07.3—281 Renewing holder for fuel pump, fuel filter and fuel reservoir

Model 107

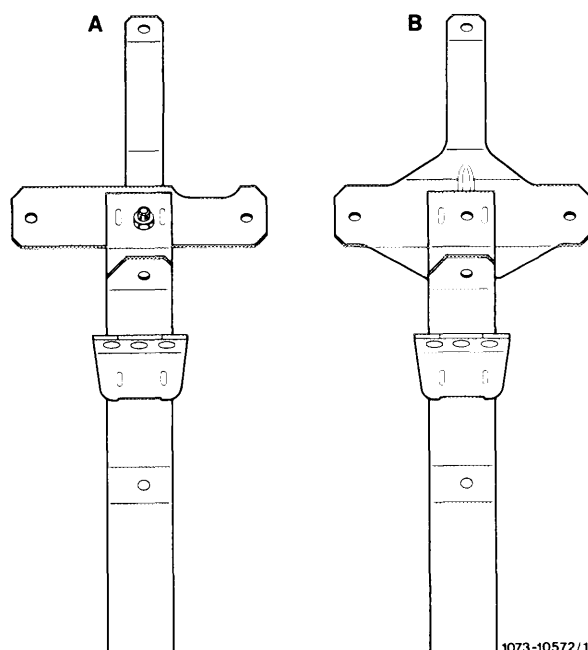
The holder has been modified to improve installation position and to increase rigidity.

A Former version
B Present version
